DIST	COUNTY	ROUTE	KILOMETER POST TOTAL PROJECT	SHEET No	TOTAL SHEETS
04	SF	80	13.2/13.9	91R1	1204

REQUEST FOR INFORMATION NOT ADDRESSED IN THIS CCO REMAIN IN FORCE

MARK	DATE	DESCRIPTIONS	BY	CH'D	CCO#
		REVISIONS			
1	02/19/08	ELECTRICAL MODIFICATIONS	MP EL	RR	42

STATE OF CALIFORNIA - DEPARTMENT OF TRANSPORTATION
Caltrans
DESIGN OVERSIGHT
BEHZAD GOLEMOHAMMADI

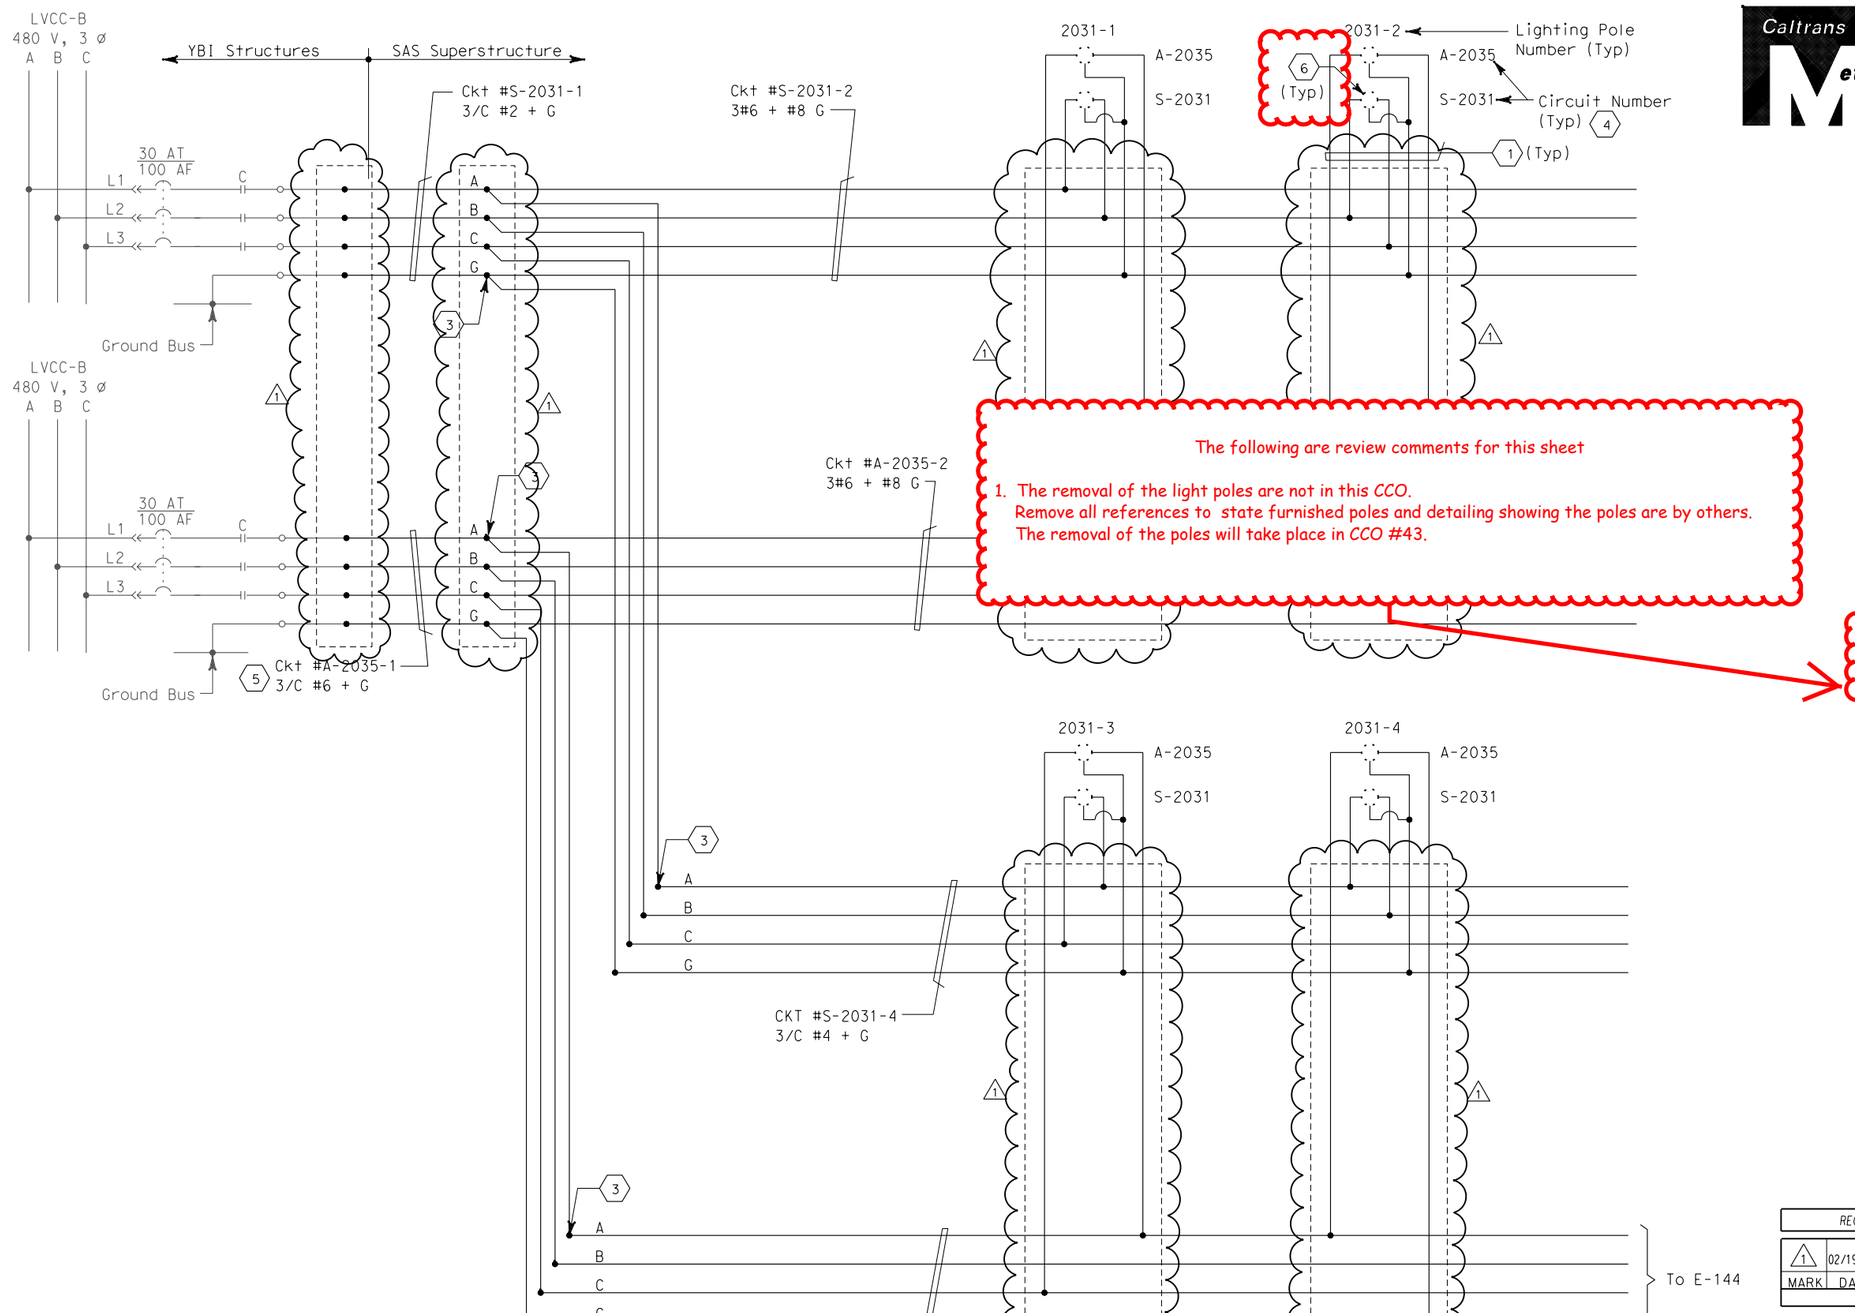
The following are review comments for this sheet

1. The removal of the light poles are not in this CCO.
   Remove all references to state furnished poles and detailing showing the poles are by others.
   The removal of the poles will take place in CCO #43.

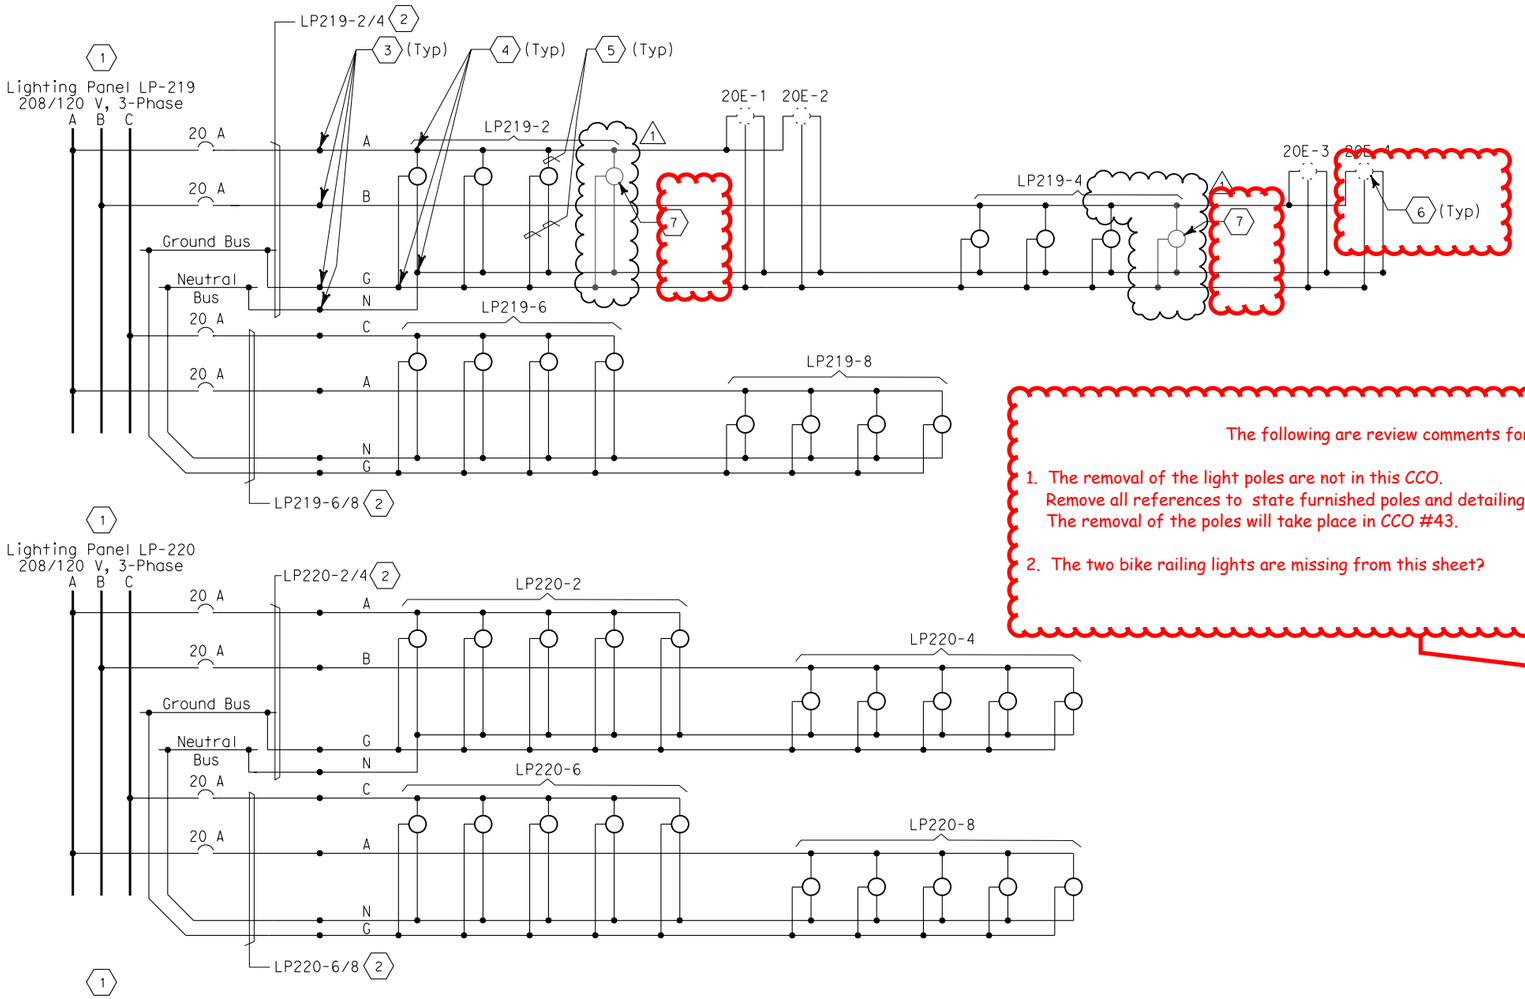
The following are review comments for this sheet

1. The removal of the light poles are not in this CCO.
   Remove all references to state furnished poles and detailing showing the poles are by others.
   The removal of the poles will take place in CCO #43.

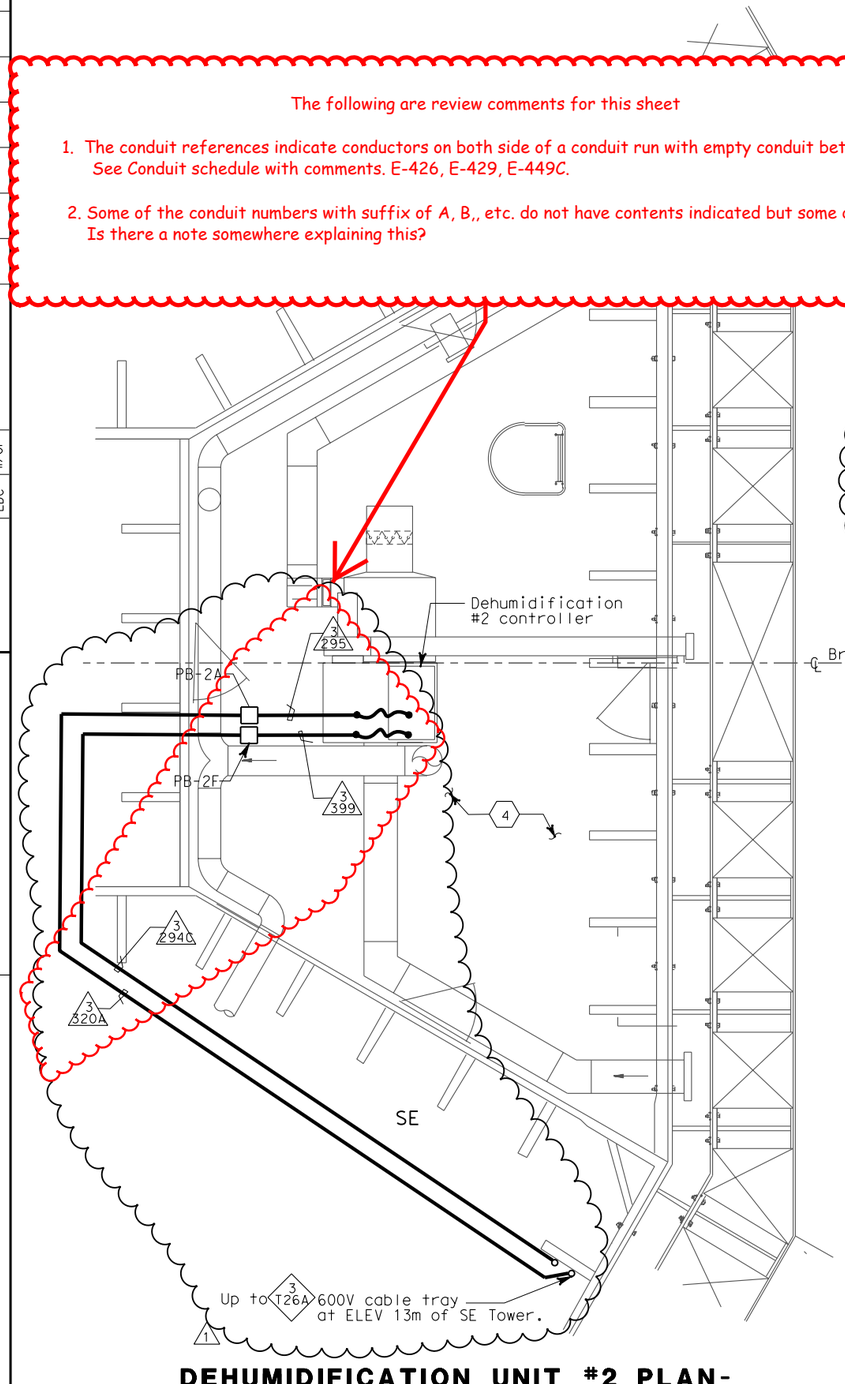
2. Some of the conduit numbers with suffix of A, B,, etc. do not have contents indicated but some do. Is there a note somewhere explaining this?
